**Subject:** Response to Weber County Engineering Review - 2016-05-12 10:00:11

**Project Name:** Cedar Cove Estates 4<sup>th</sup> Amendment

PROPOSED DRAINAGE DITCH  
 REPLACEMENT ON LOTS 33 & 34  
 CEDAR COVE ESTATES 4TH AMENDMENT

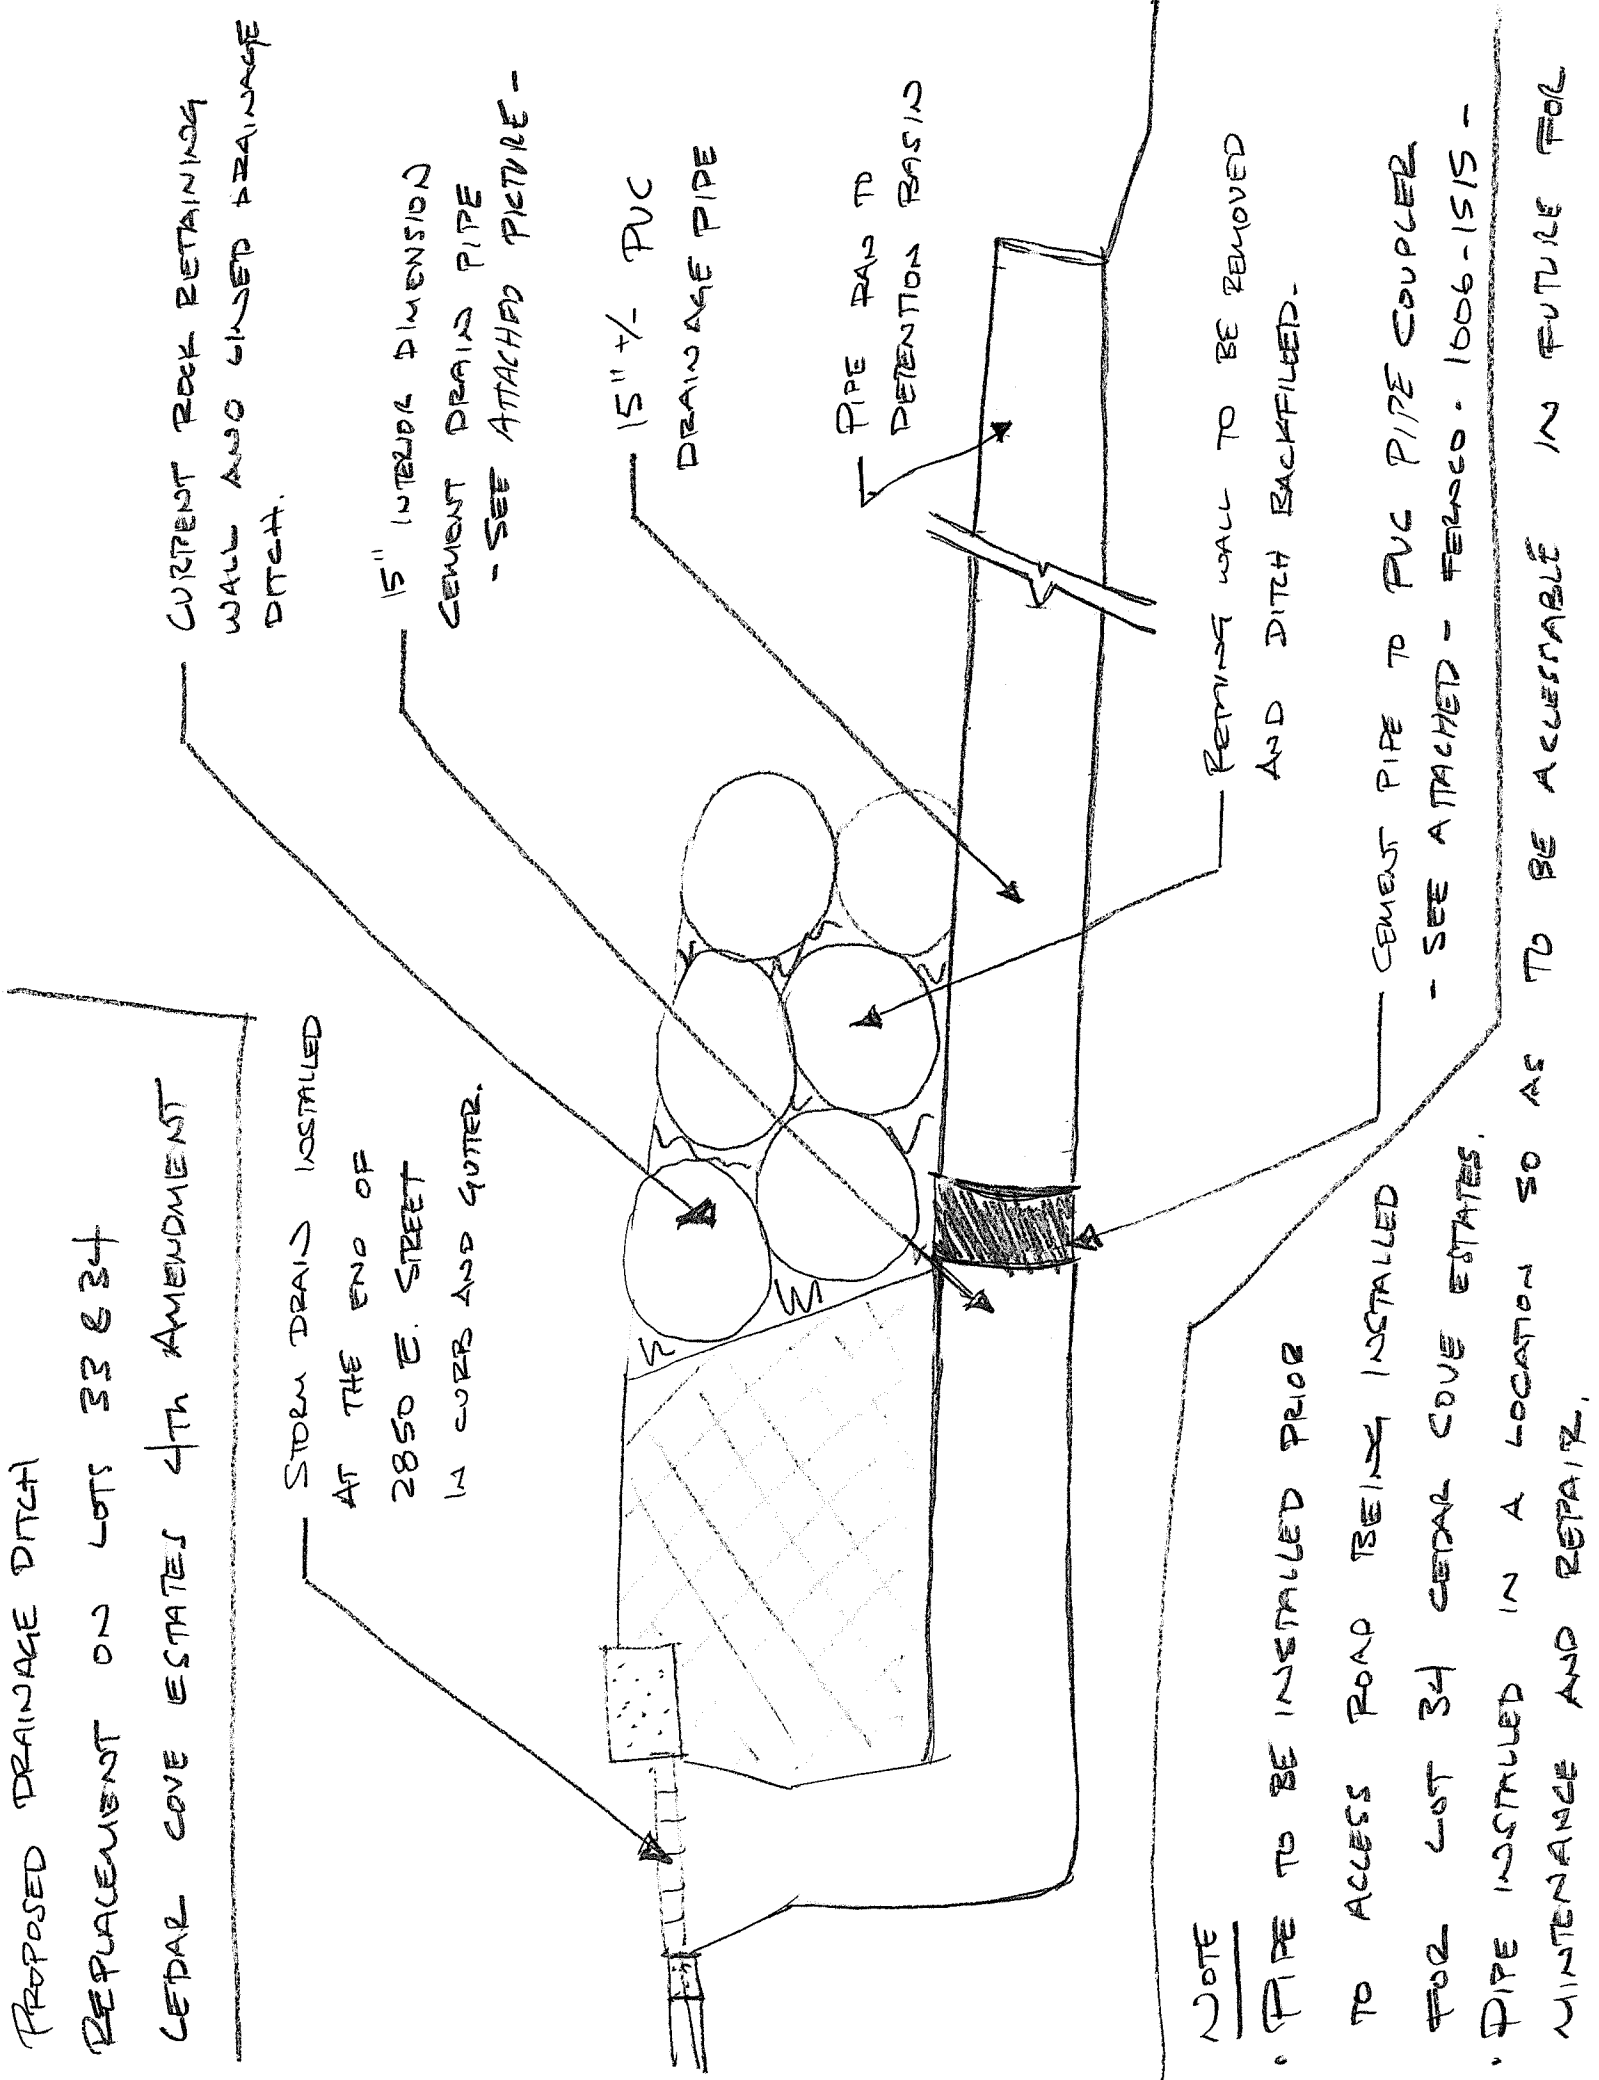
"I have a concern regarding the Access to the Detention Basin. Can wording be added to the 15 foot drainage easement across Lot 34 making it both an access easement and a drainage easement? That would address the need to be able to get to the detention basin for maintenance and inspections. It might be wise to show where the existing roadway is as it would appear to meander outside of the right of way. If the applicant is willing the 15 foot easement across lot 34 might be widened to 20 feet as both the existing ditch and the access to get to the basin is needed. Blane Frandsen PE"

This change to the final plat is currently taking place. The 15 easement on lot 34 is being changed to reflect a 20' easement. Also, the note "Access and Drainage Easement" that is currently shown on lot 33 is being added to lot 34. As per our discussion at 11:20 am on 2016-05-19 we are looking at installing a pipe that would attach to the current drainage pipe that runs into the ditch along the side of lot 33 and 34. This pipe would alleviate the need for the ditch and would allow it be removed along with its retaining walls and backfilled. The paved access to lot 34 would then be paved down the 20' easement in a location such that future access for maintenance or repair without cutting the road would be possible. See attached sketch.

NOTE  
 PIPE TO BE INSTALLED PRIOR  
 TO ACCESS ROAD BEING INSTALLED

FOR LOT 34 CEDAR COVE ESTATES.  
 PIPE INSTALLED IN A LOCATION SO AS  
 TO BE ACCESSIBLE IN FUTURE FOR  
 MAINTENANCE AND REPAIR.

REMOVING WALL TO BE REMOVED  
 AND DITCH BACKFILLED.
